BUILDING PERMIT

Located At 60 AUTUMN LN

Job ID: 2012-03-3511-ALTR

has permission for Phase I: Build a 14 foot by 28 foot deck only (Separate Permit Required for Wall/ Roof Framing).
provided that the person or persons, firm or corporation accepting this permit shall comply with all of the provisions of the Statues of Maine and of the Ordinances of the City of Portland regulating the construction, maintenance and use of the buildings and structures, and of the application on file in the department.

John Voyer 60 Autumn Lane, Portland

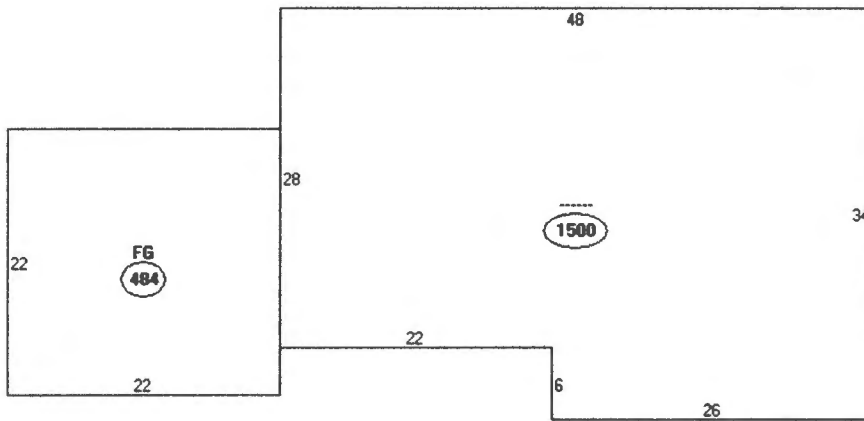
1. This permit is being approved on the basis of plans submitted. Any deviations shall require a separate approval before starting that work. Your submitted plot plan shows that you have 30 feet to the rear property line. 25' is the minimum required from the structure to the property line.
2. As discussed during the review process, the property must be clearly identified prior to pouring concrete and compliance with the required setbacks must be established. Due to the proximity of the setbacks of the proposed addition, it may be required to be located by a surveyor.
3. This property shall remain a single family dwelling. Any change of use shall require a separate permit application for review and approval.

Front: N/A ^{shows}
 REAR: 25' ^{min - 30'}
 Side: 12' ^{min - 30'}

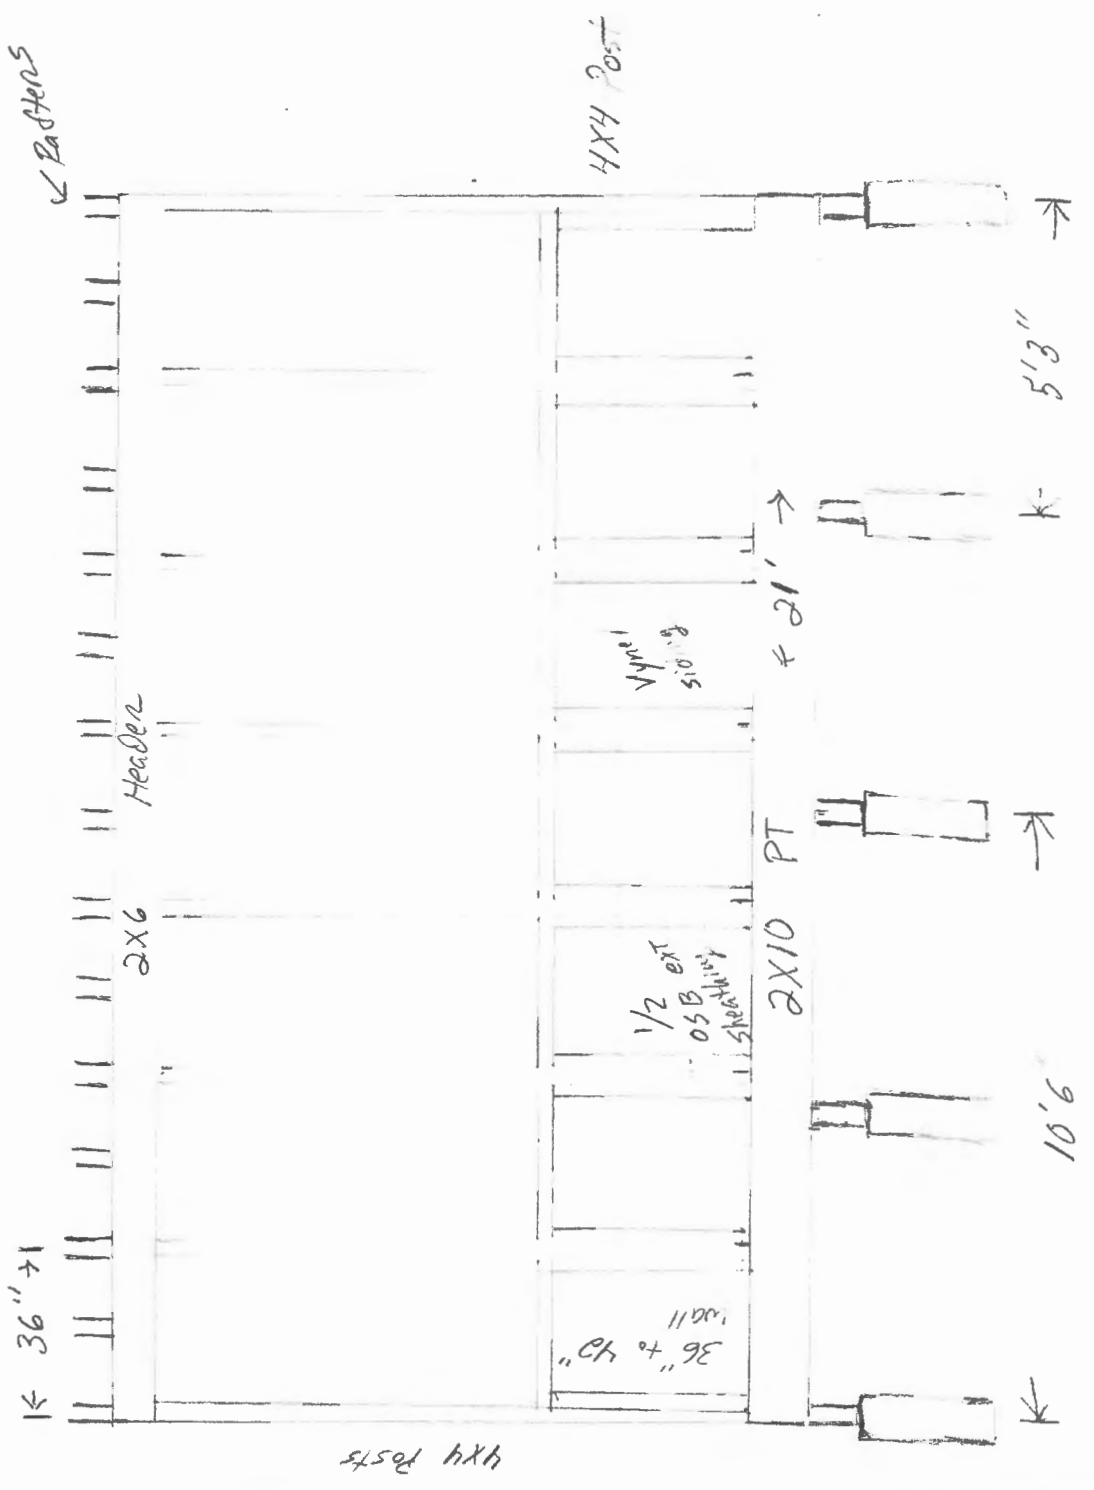
8. **Note: (SPF #) 2 by 10 inch floor joist 16 inches O.C. max span is 15 foot – 5 inches; proposed max 2 by 10 inch Girder span is 5 foot- 3 inches.**

Can you provide a cross-section/ roof framing detail for the new addition, see below?

- Pitch, Span, Spacing & Dimension (Table R802.5.1(1) - R 802.5.1(8)
- Roof Rafter; Framing & Connections (Section R802.3 & R802.3.1)
- Include Collar Ties, or Structural Ridge; and how this is posted to grade.
- Sheathing (Table R503.2.1.1(1))
- Roof Covering
- Finished Headroom

- Pitch: 7/12
- Sheathing: 1/2" OSB
- Roof Covering: 30-year, 3-tab asphalt shingles

Phil Bridges came by the house this morning and took some measurements so that he could finish off the attached drawings.

He said he thought the drawings would answer your questions, with one exception--he won't truly know the finished headroom until he gets in rough deck structure in place. However, he is pretty confident, based on the attached measurements, that the headroom will be at least as high, and probably higher, than the headroom currently in the house (about 7'4").
